出國報告（出國類別：其他）

赴美國亞瑞華核能(AREVA NP)公司進行核二廠爐心設計分析稽查及議題討論

表 2 行前 13 項議題與回覆

中子分析工程師主管 Dang Patchana 於 8/21(三)下午表示，關於 CASMO-4 程式從專題報告(topical report)至今所用之版本的主要改變，是由 Studsvik 公司所提供之 1.14 版演進至 2.05 版。雖然這些版次變更均是相當基本的，而非重大改版，但 AREVA 公司仍進行相關影響評估，並確認改版所致之影響是在專題報告所允許的變動範圍之內。

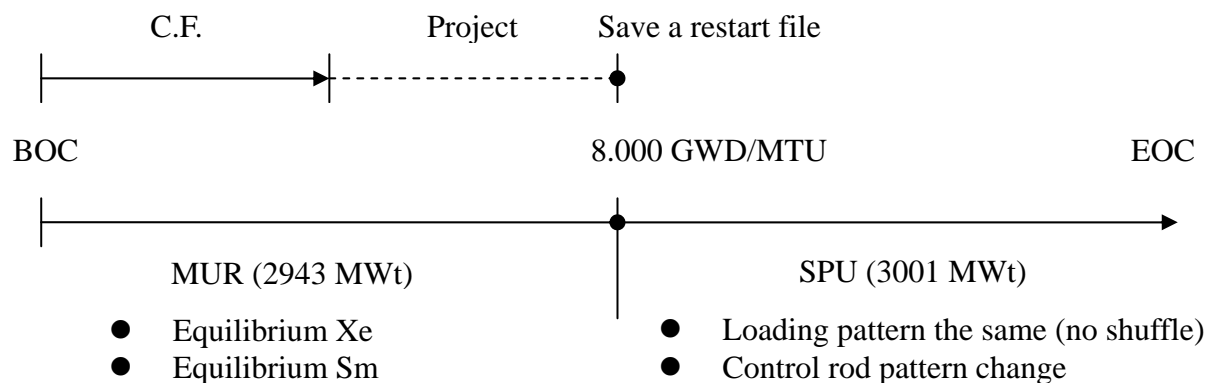
5. In operability assessment, which modified K-factor method AREVA used?

目前 modified K-factor 有兩種計算方式，一種是根據每根燃料棒的軸向 K-factor 組成去計算每根燃料棒的 CPR，是較費時的計算方式；另一種為：燃料束中，將各軸向平面中最大的 K-factor 選出，接著計算該燃料束的 CPR，該方式可節省計算時間並得到較保守的結果。目前可用性評估報告(OA)在計算 CPR 時，選用第一種較費時的計算方式來分析 modified K-factor 和 approved K-factor 之差異。
